Project Title: Refurbish Elevators and Replace Controls

Solicitation Questions and Answers
for
Refurbish Elevators and Replace Controls
Project: 437-22-101, RFP: 36C26324R0021
12/15/2024

Solicitation Questions and Answers (updated 3-26-2024) for
 Refurbish Elevators and Replace Controls
 Project: 437-22-101, RFP: 36C26324R0021

Drawing Number
AD5.22

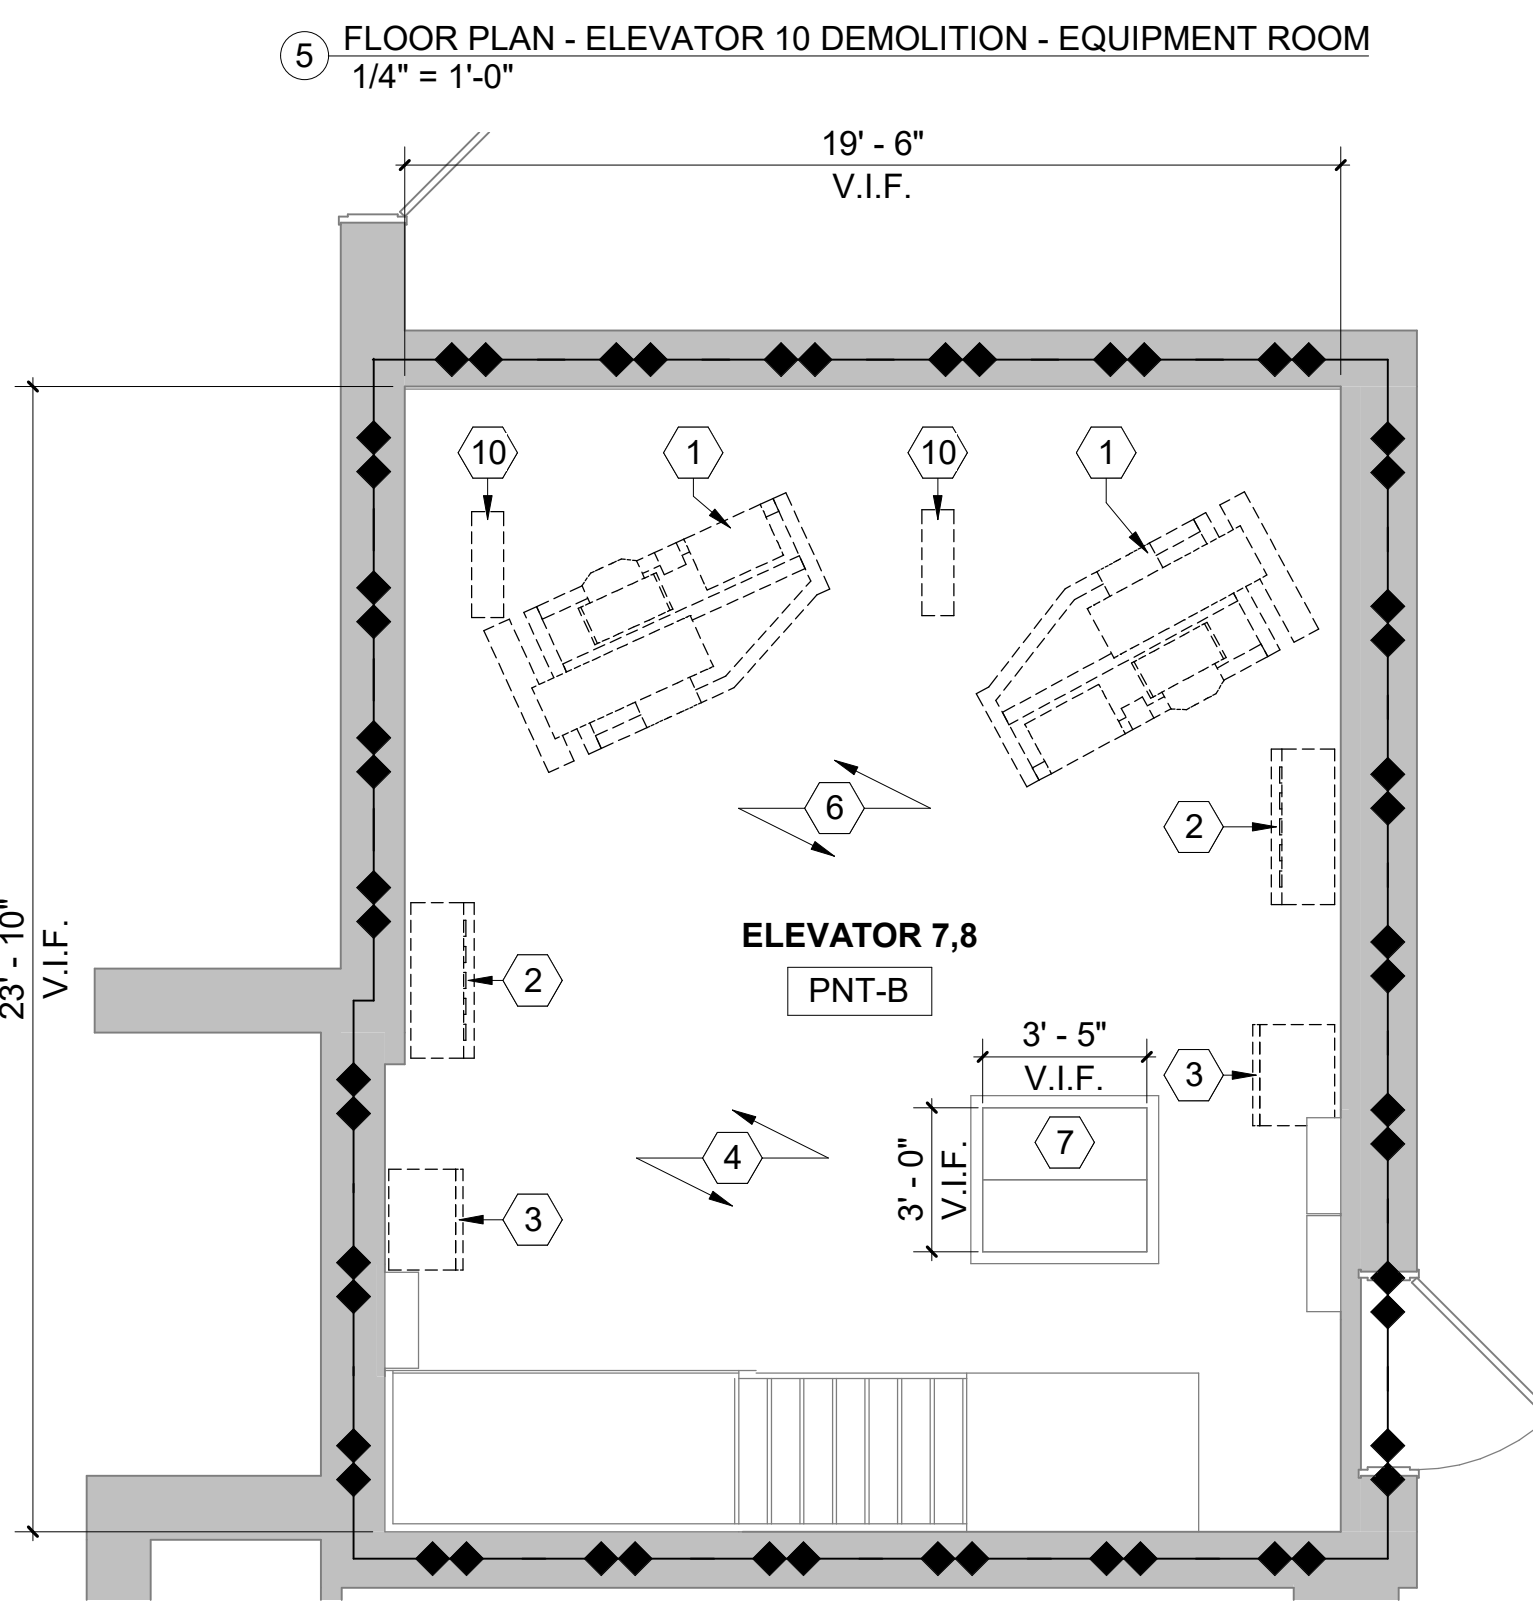
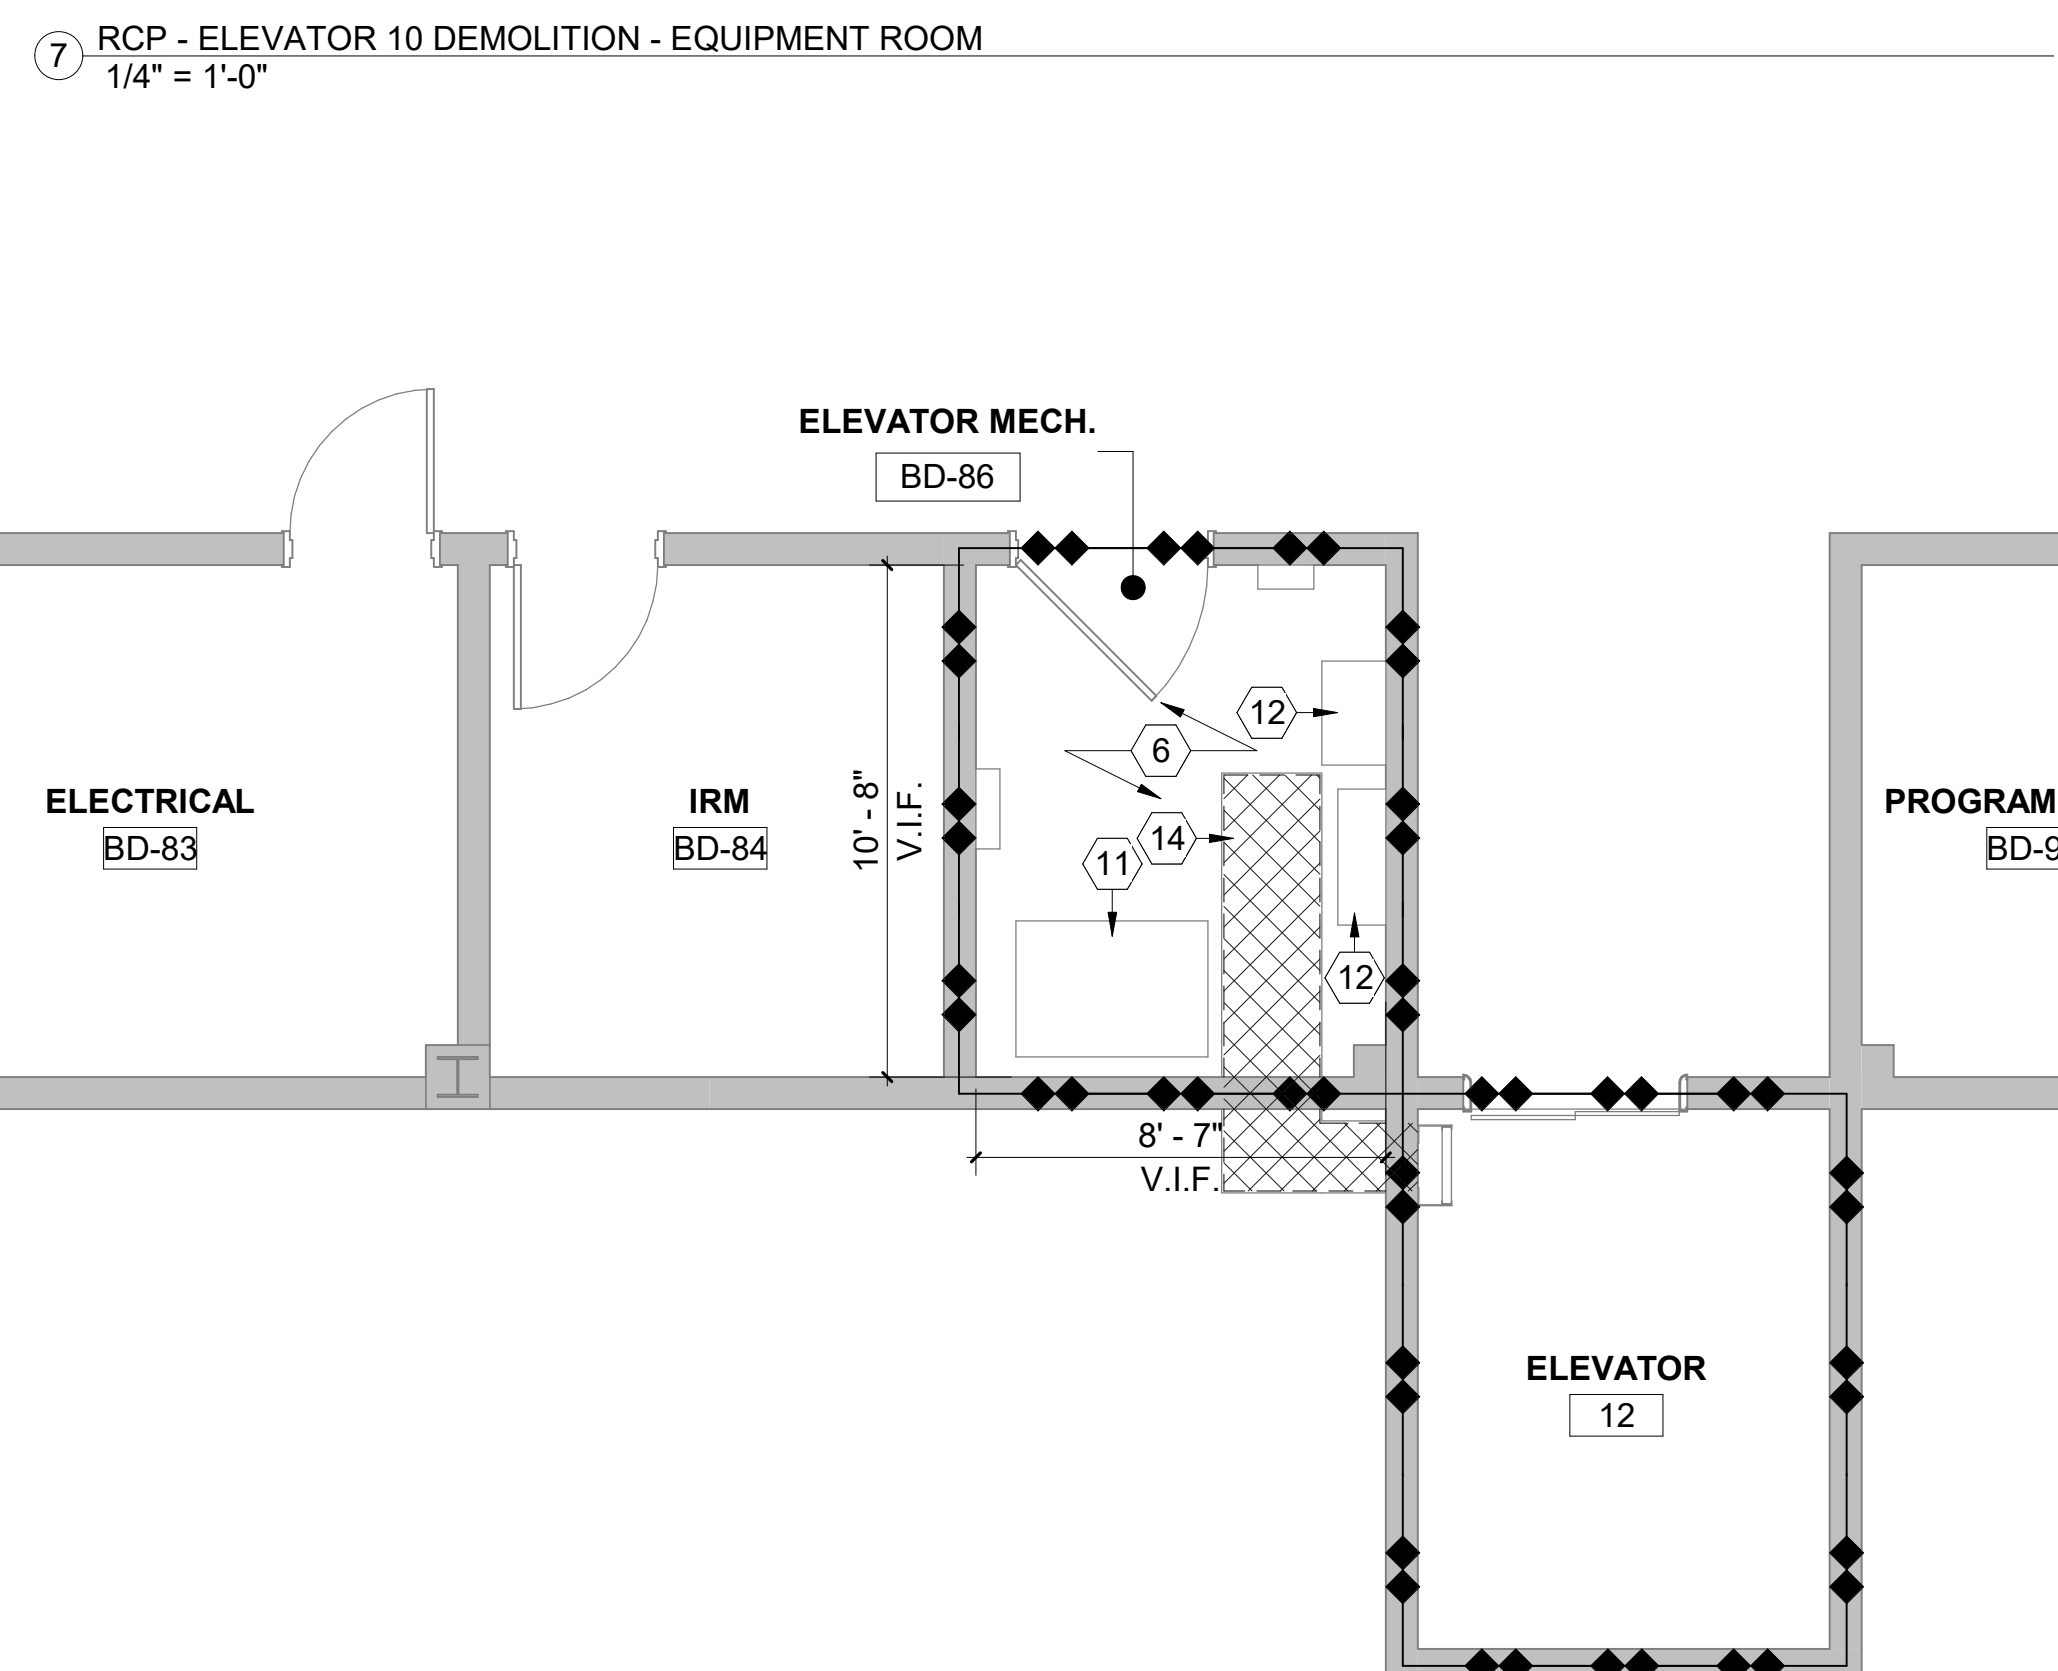
57.	Drawing AD5.22 Key	Key note #1 VS 14 21 10-17 section 2.17	The Specification calls for the geared motor, see update to drawing sheet

note #1	Please confirm if the elevator contractor is to install new gearless elevator hoist machines for elevator 1-8 or geared traction machines as the specifications and drawings conflict and there is a cost difference.	AD5.22 to make all drawing references calling for Geared Motor.

Drawing Sheet AD5.22 ENLARGED PLANS – PENTHOUSE / EQUIPMENT ROOMS - DEMOLITION – See revised drawing sheet for the adjustment of keynotes # 1.
